M1000B INK FOUNTAIN MOTOR TACH ENHANCEMENT

WHAT'S CHANGING?

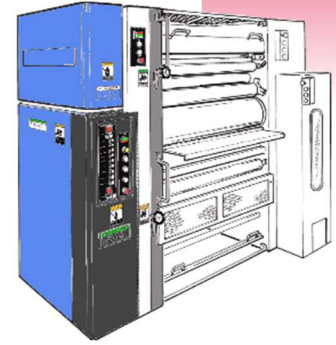
This tachometer (tach) has recently been discontinued and is no longer available from manrolandGoss.

To minimize your disruption due to a tach failure, manrolandGoss has investigated the use of alternate tachs, as well as different fountain roll speed feedback solutions. On-press testing has verified that permanently eliminating a tachometer from the system and replacing the existing Minarik drive [wp5335490] with a new Minarik drive configured for 'armature voltage feedback' is suitable for accurate speed control of the fountain roll.

The solution, when this tach fails, is to disconnect the tach wiring and to replace the existing Minarik drive [wp5344960] with a new Tach Replacement Kit [wp5948010] which consists of a new Minarik drive that will be set up for 'armature voltage feedback' instead of 'tach feedback'.
